Re: Taxiway Improvements
Watertown Regional Airport
Watertown, South Dakota
AIP #3-46-0058-047/048-2025
Helms #A-9070

ADDENDUM NUMBER 1

The following modifications are made to the plans and specifications for the Taxiway Improvements Project, Watertown Regional Airport:

ESTIMATE OF QUANTITIES

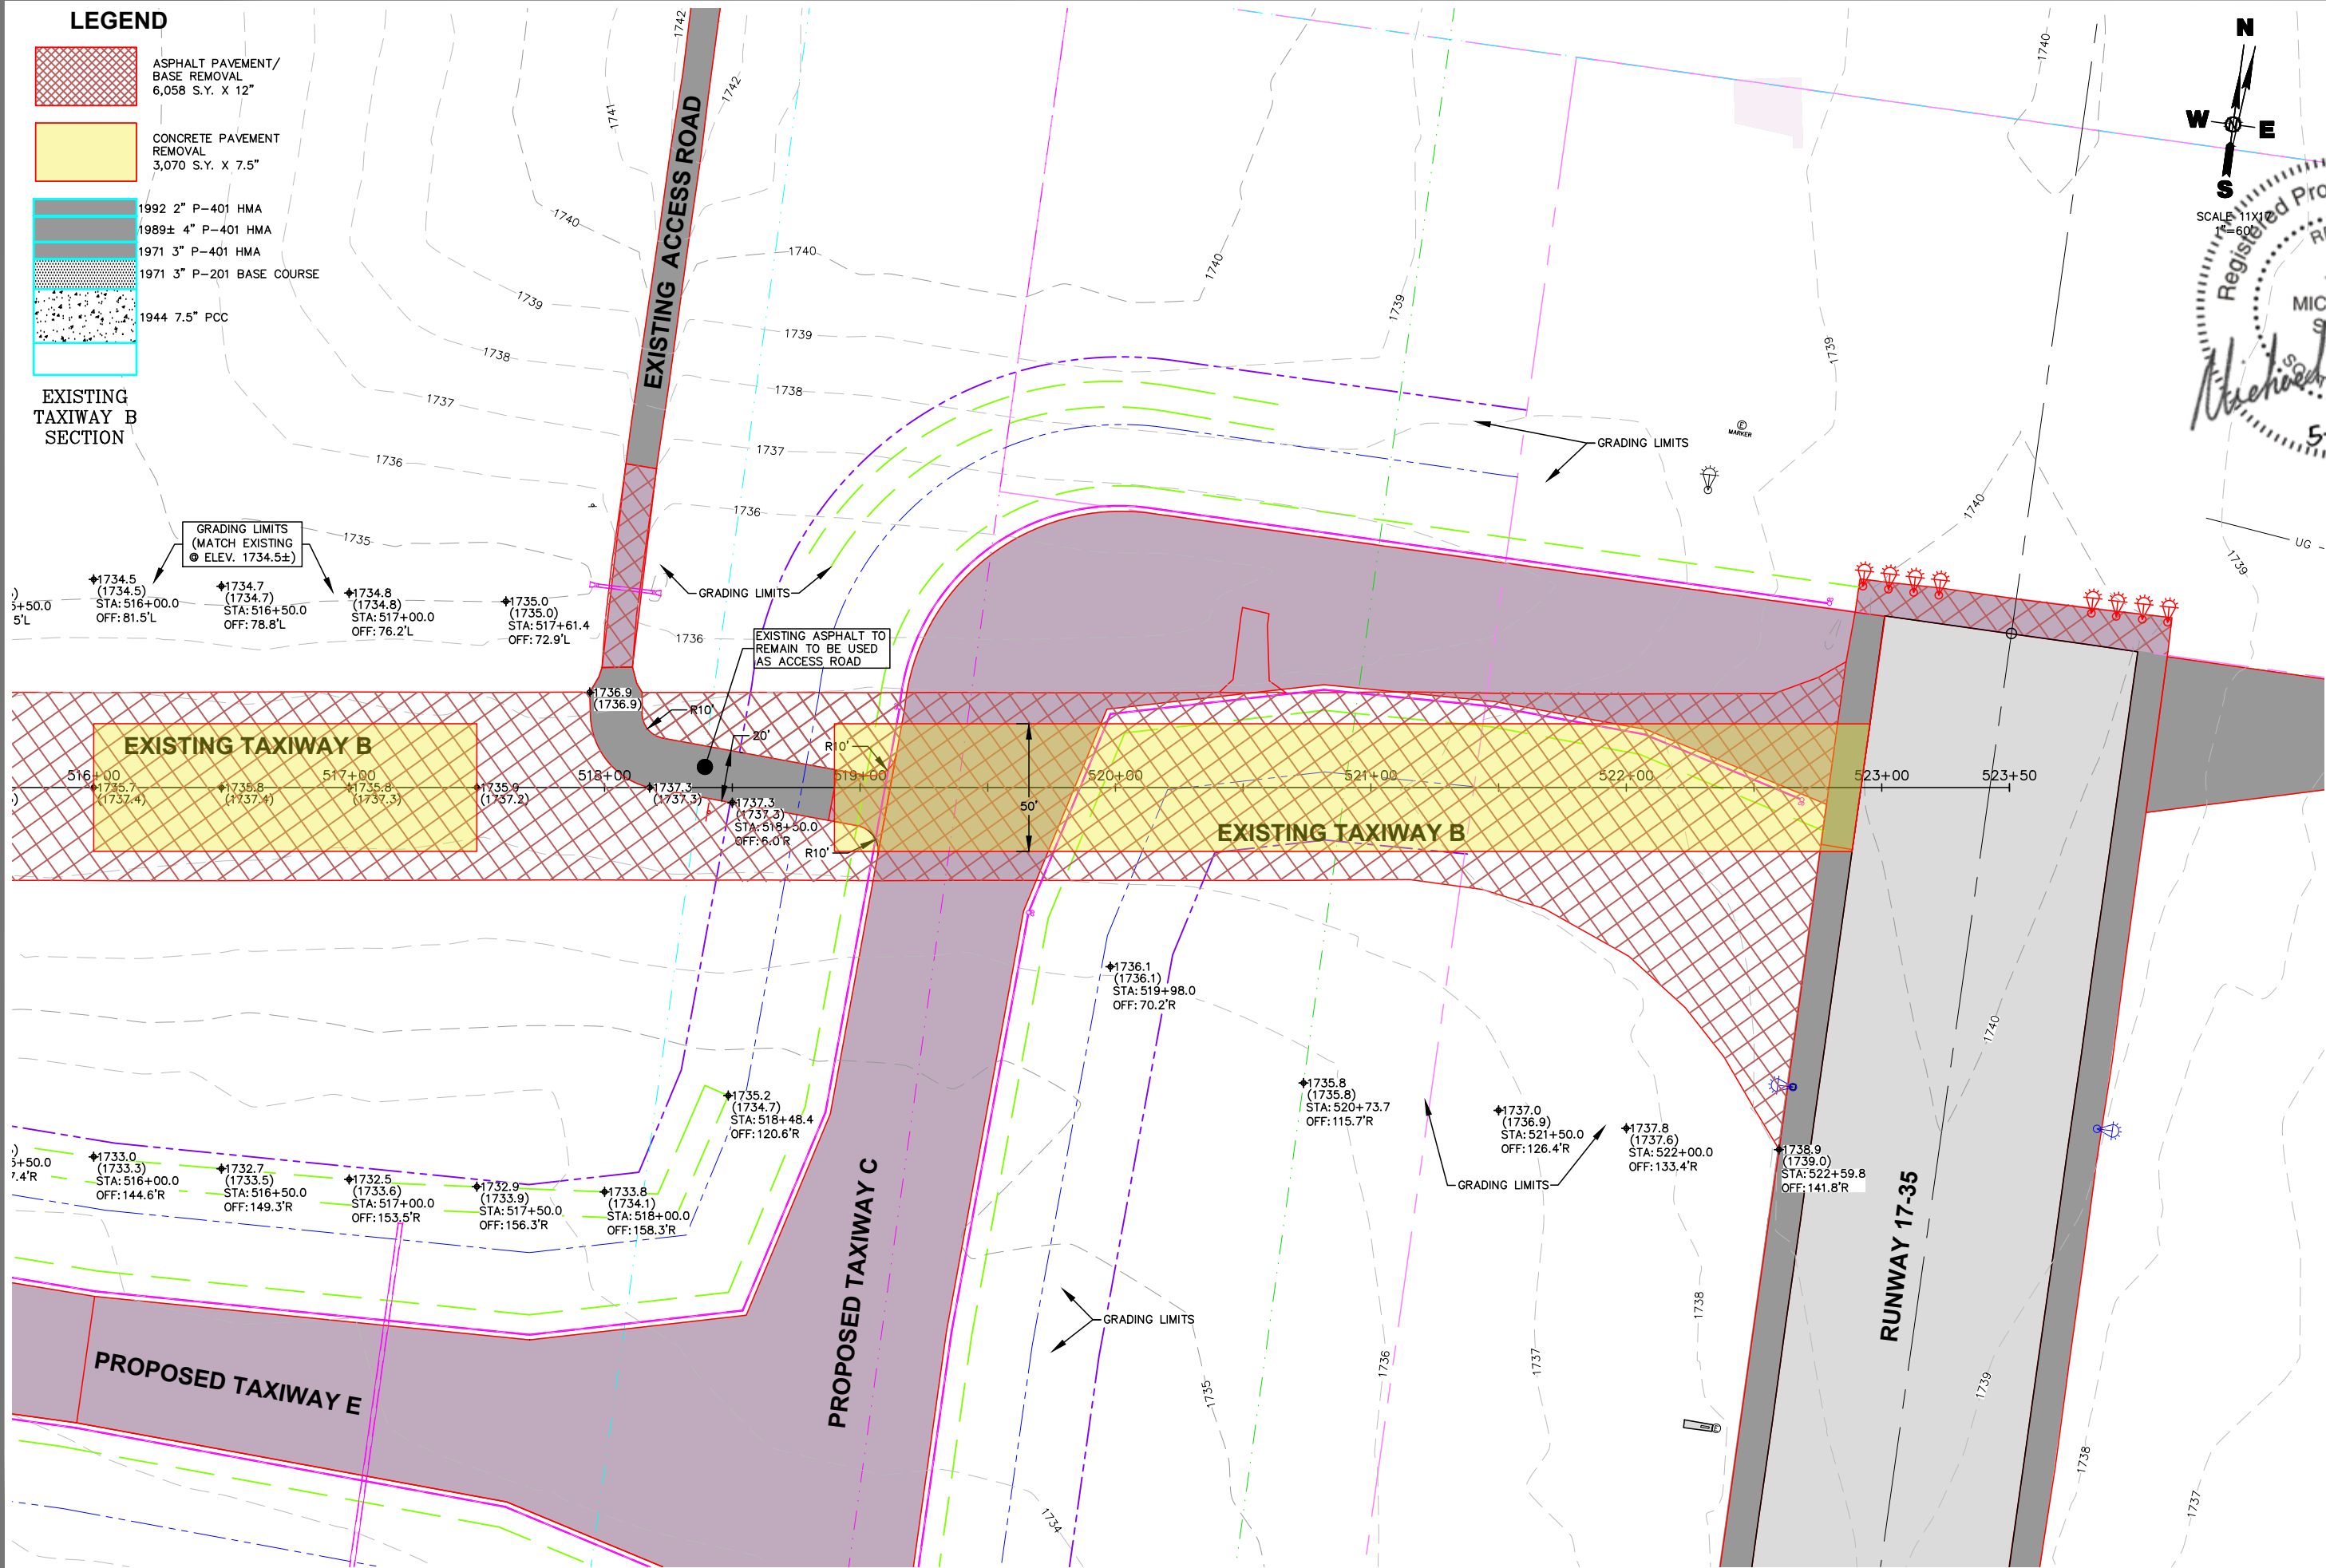
6. Estimate of Quantities, Sheet 24, delete in its entirety and replaced with the attached Sheet.

Updated the Estimate of Quantity Tables.

EXISTING TAXIWAY PAVEMENT
REMOVAL AND GRADING PLAN

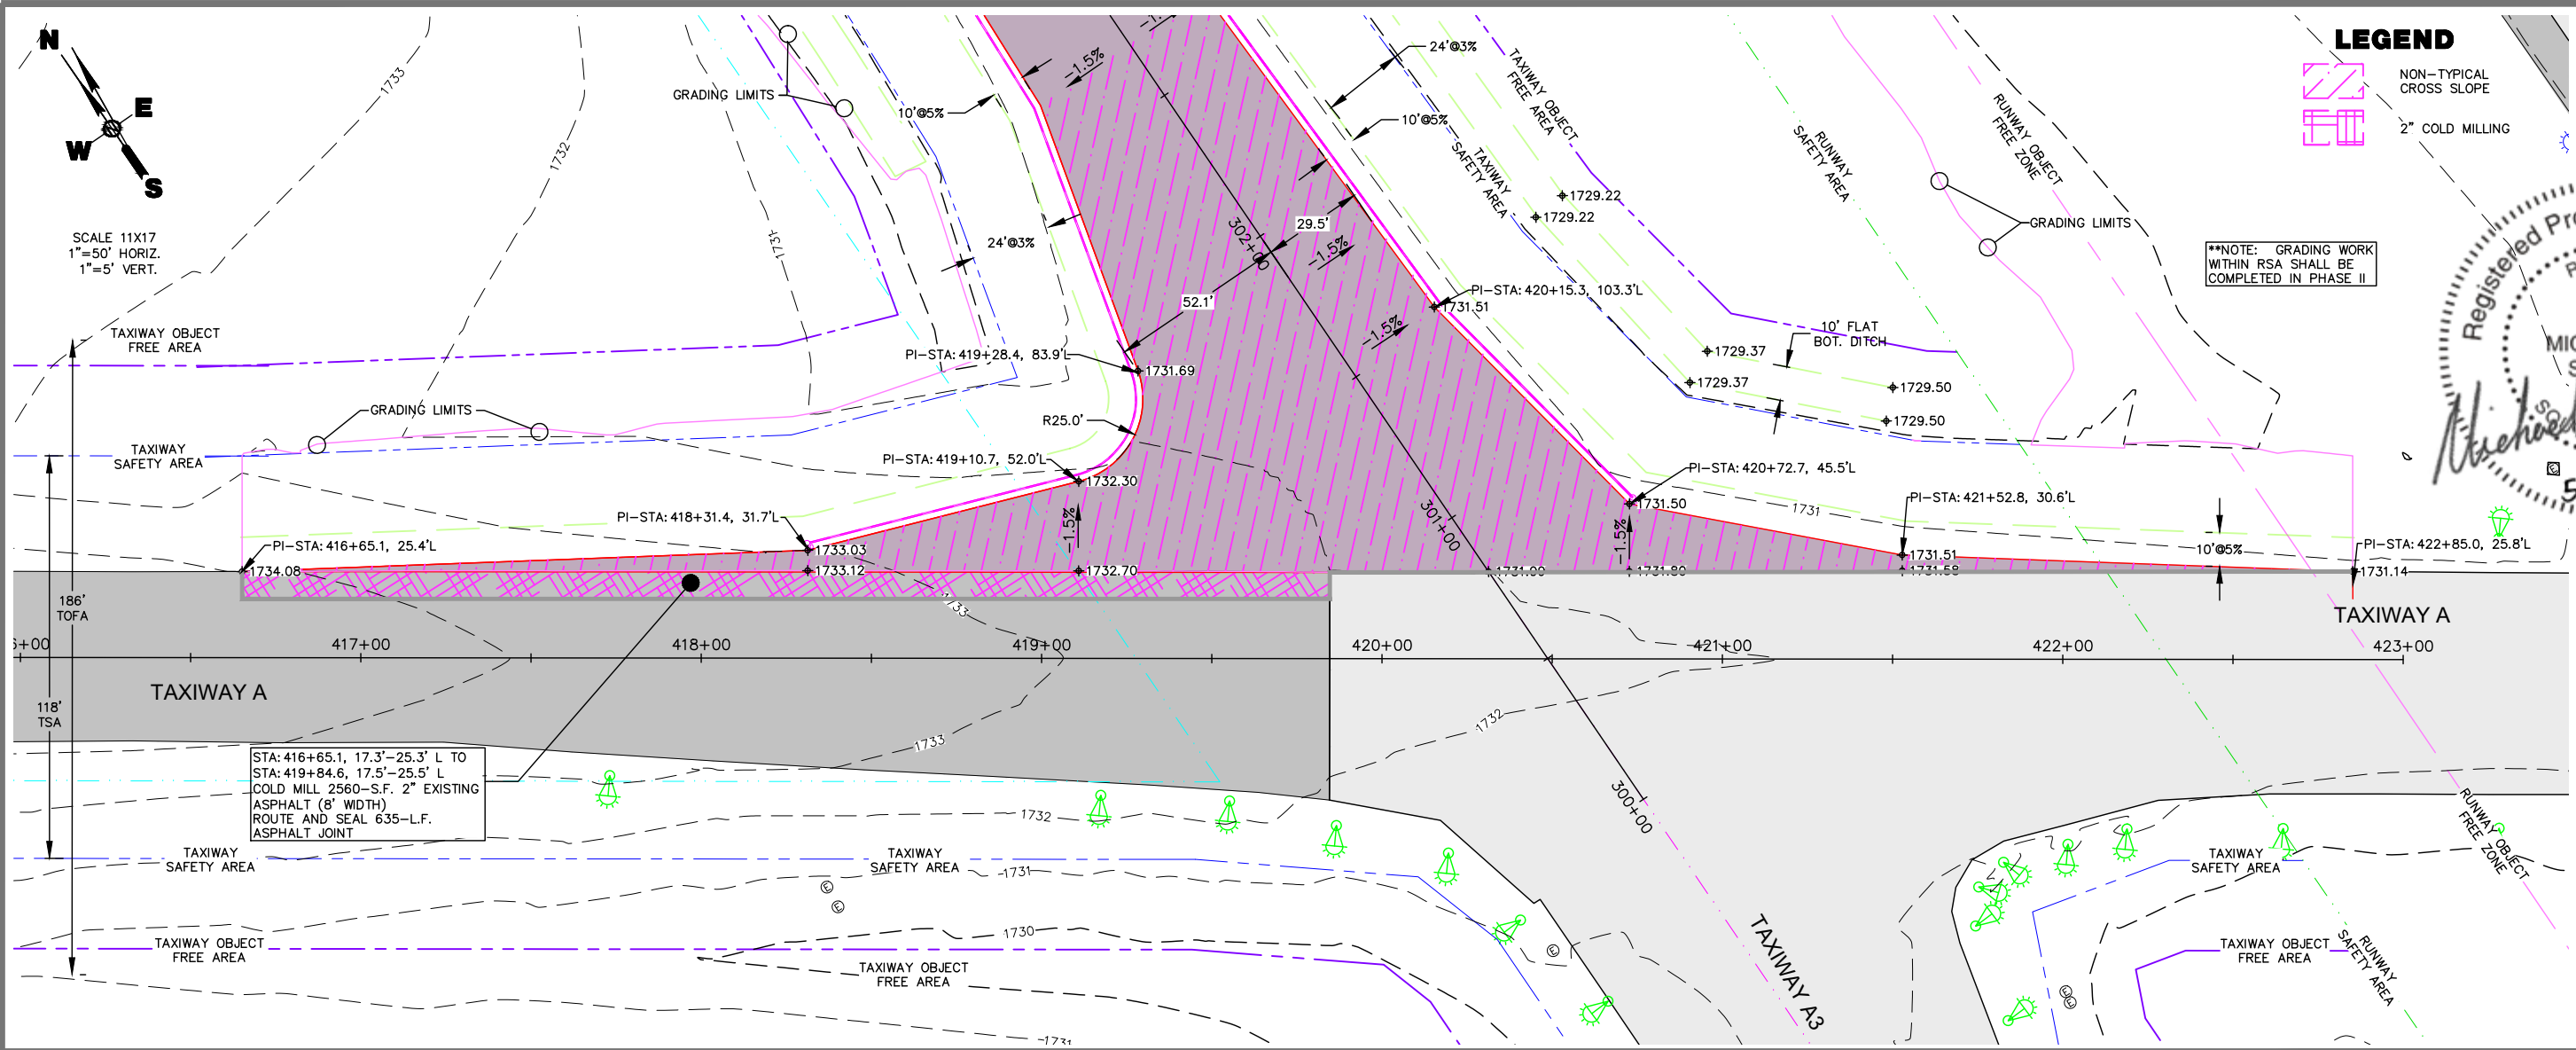
8. Existing Taxiway Pavement Removal and Grading Plan, Sheet 18, delete in its entirety and replaced with the attached Sheet.

Added Pavement Removal for the relocation of the Runway 17 Threshold Lights.
